Subject: Planning Application for Garden Office - 13 Chalcot Gardens NW3 4YB - 13 Chalcot Gardens: 2024/4823/Proposed replacement Outbuilding (Garden Studio) within the rear garden

Re: 13 Chalcot Gardens: 2024/4823/Proposed replacement Outbuilding (Garden Studio) within the rear garden.

Figure 1. Garden Studio Proposal and scale as shown in application. (Ref pg. 11)

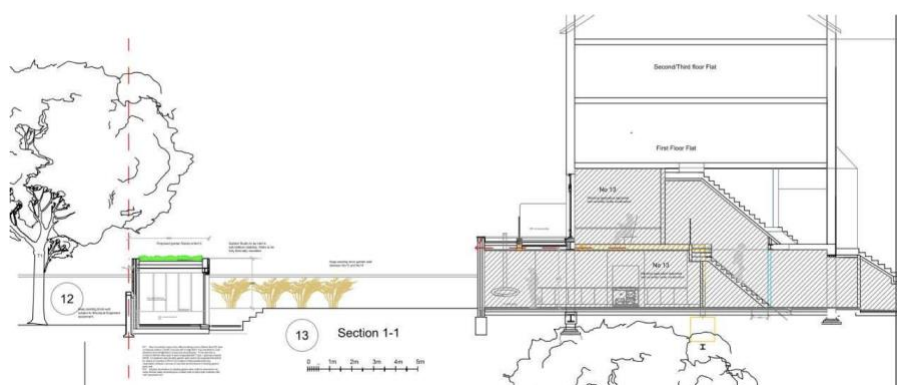
The Garden Studio is set 10m from the main residences and facing the residences and as outlined in Policy A1 Section 2.4 this condition is not met. Further to this the nature of the low boundary walls, which is in the character of the Conservation Area and Gardens, will mean inevitable overlook. Please see Figure 1 below for reference of distances as per application.

Figure 3. Overlook of garden building and agreed roof terrace on neighbouring residences

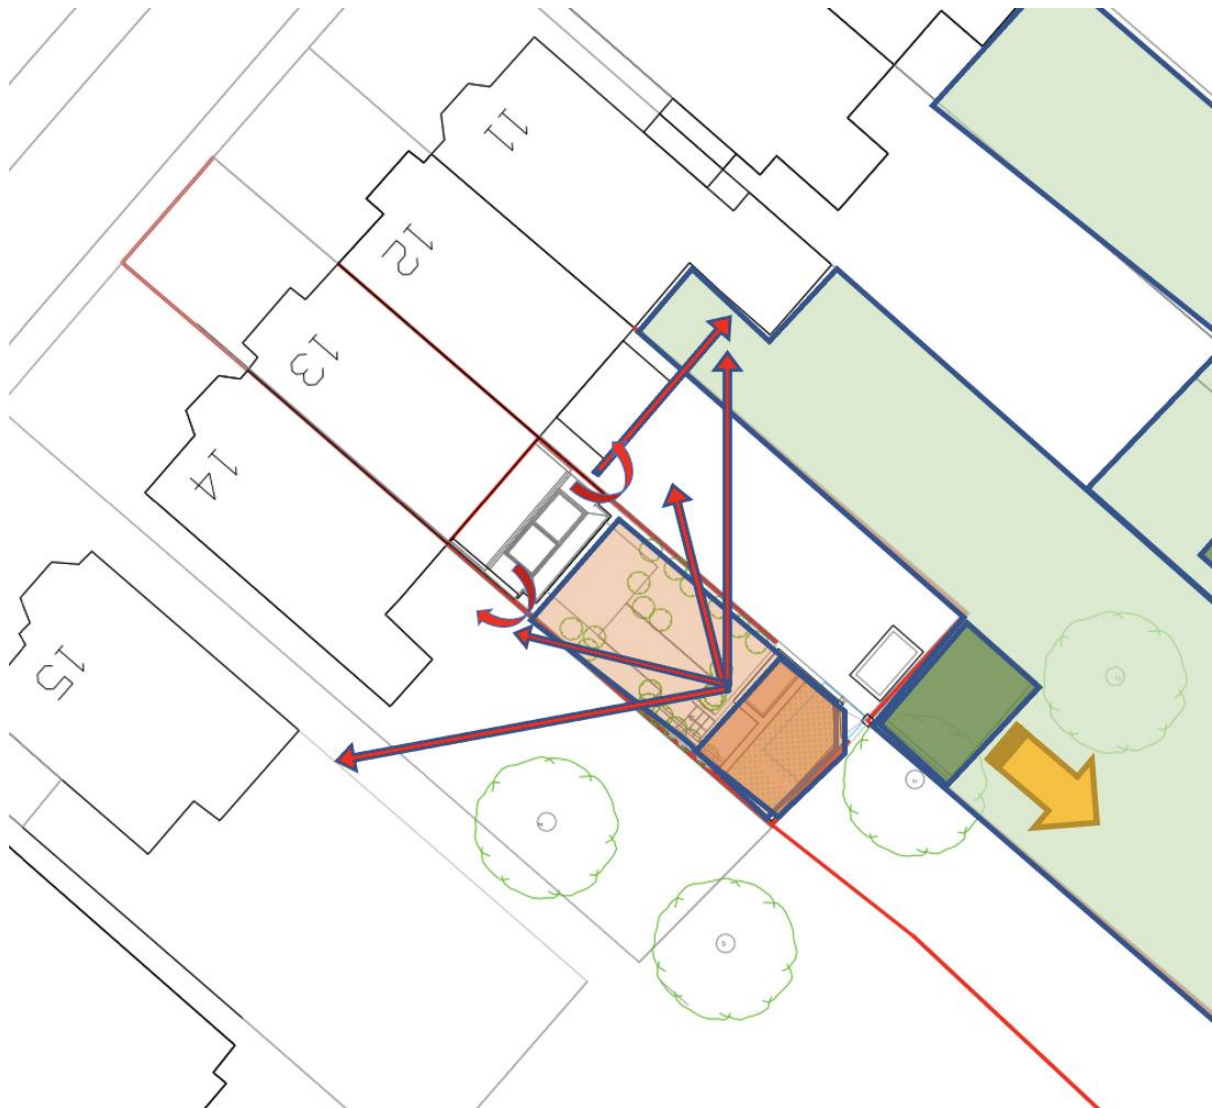
The approval of a Garden Studio in conjunction with planning for an extension already provide outlook in all directions including from the sides and directly onto resident rooms. See Figure 3 below and Images 1 to 4.

The previous outlook covered a 180-degree angle impacting privacy from the sides of residents, however with a further outlook now facing the building the cumulative outlook of both proposals in combination gives a 360-degree outlook. When the plans for the Garden Studio are added to this, neighbouring properties would now have to be blinkered by 1.7m high screening. Following the same logic, will have to have screening continuing for a further 10m to mitigate the impact on privacy. Even if it was feasible to add screening to a height of 1.7m across both boundary walls, it would still be unlikely to preserve the privacy of the remaining 4 floors in each of the affected 4 residences (16 floors and 4 balconies No. 10, No. 11, No. 13, No. 14). The remaining outlook of the proposed Garden Studio would still be the upper residential windows even if a screen was added.

Figure 5. A large portion of the boundary wall is raised.

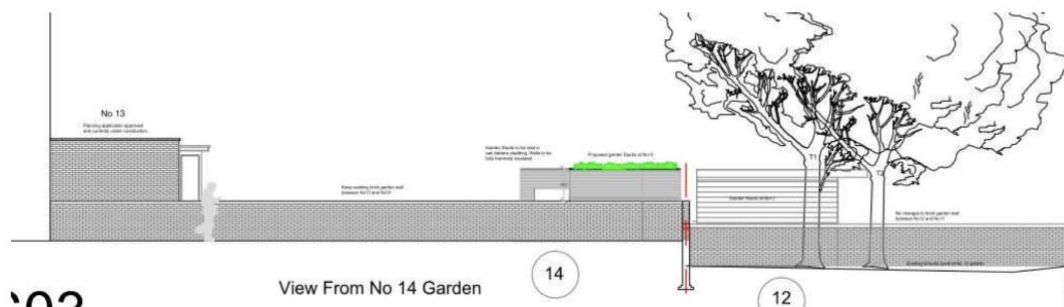
Further to the erosion of the garden space the erection of high walls on either side take away from the character of the conservation area defined by low boundary walls which allow for a sense of openness and the free movement of local wildlife (see Figure 5). The Garden Studio proposal is also wall to wall and effectively hermetically seals the Garden in no. 13 from the other gardens impacting the nature of the conservation area and the movement of wildlife (see Figure 6). The above statement is echoed in the Official Planning Guidance on Design : Paragraph 4.41 of which the sections states:
